No. 214ST-03-173

MODEL AFFECTED: 214ST

SUBJECT: INTERMEDIATE GEARBOX MOUNTING
HARDWARE CHANGE

FIGURE 1

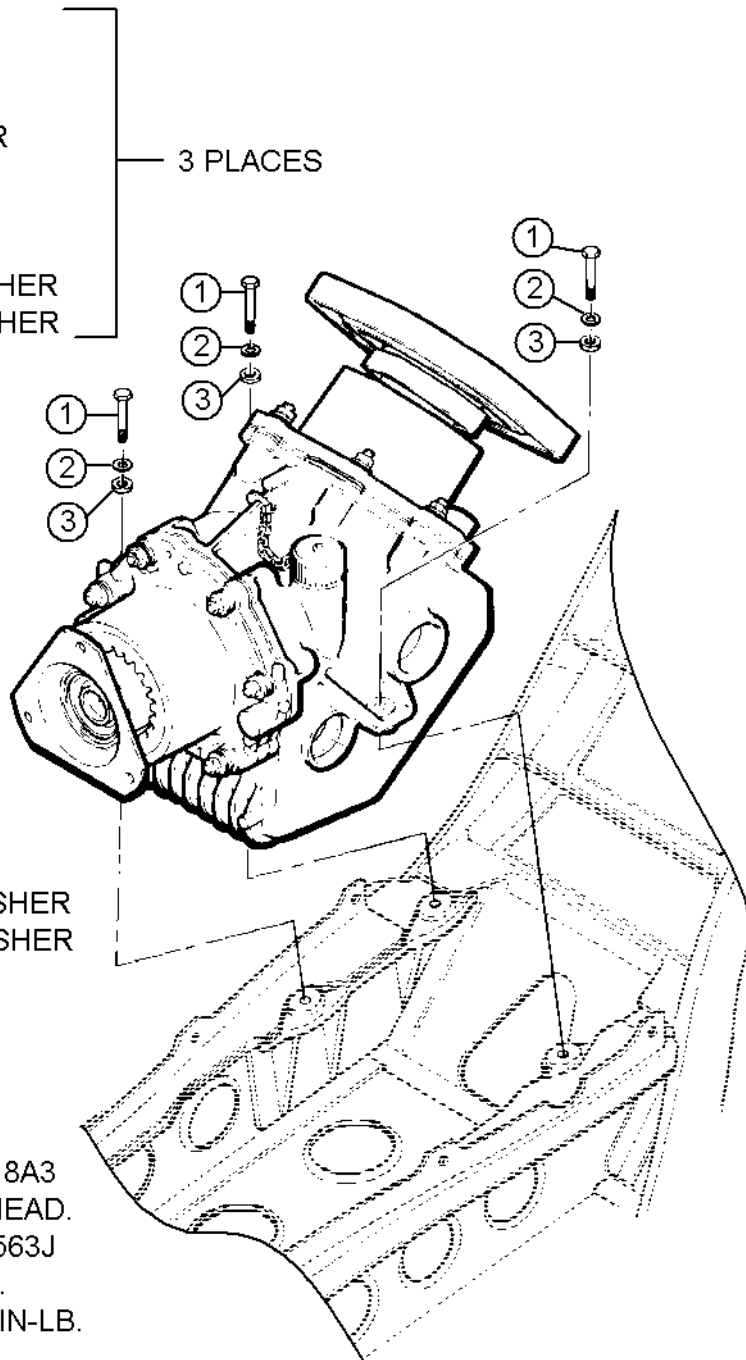
1. During installation of the intermediate gearbox assembly, replace existing hardware with new hardware as noted on Figure 1.
 - a. Insert bolt (1) with washer (2) under bolt head and washer (3) next to case through mounting lugs of gearbox into nut plates in tailboom.
 - b. Torque bolts 100 to 140 inch pounds and secure with lockwire (C-405).
 - c. Apply sealant (C-308) around periphery of mating surfaces of gearbox to airframe.
2. All other intermediate gearbox installation requirements, as defined by the 214ST Maintenance Manual, remain unchanged.

- P/N AN5H15A BOLT
- P/N AN960-516 WASHER
- P/N AN960PD516 WASHER

- P/N MS9796-25 BOLT
- P/N 140-007-21-18A3 WASHER
- P/N NAS1149D0563J WASHER
